# CONSTRUCTION STORMWATER GENERAL PERMIT INSPECTION REPORT

State of Washington Department of Ecology

The Electron Hydro LLC Intake project is covered under the State of Washington's Construction Stormwater General Permit (CSWGP). The CSWGP is a National Pollutant Discharge Elimination System (NPDES) and a State Waste Discharge permit for discharge of construction-related stormwater. Carol Serdar had previously been to the site a few years' prior, during the JARPA review for the then proposed re-construction of the barrier dam and intake structure and on 11 August 2020 in response to ERTS699710.

**Photo 7**

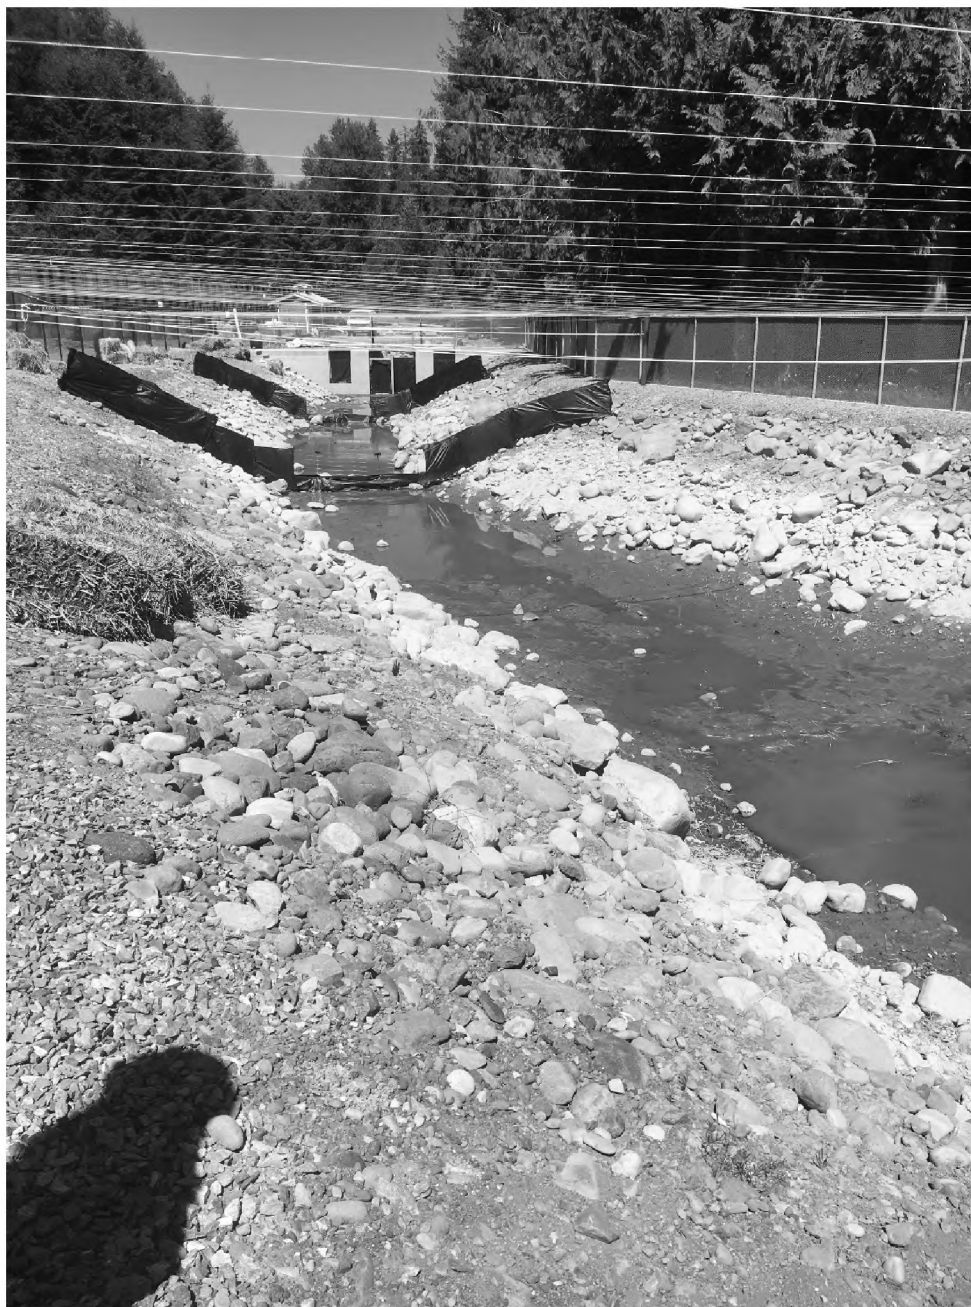
Photo Description: Sediment Pond has a standpipe and outlet structure (in shadow); discussed BMPs for additional settling out of fines and cleaning schedule.
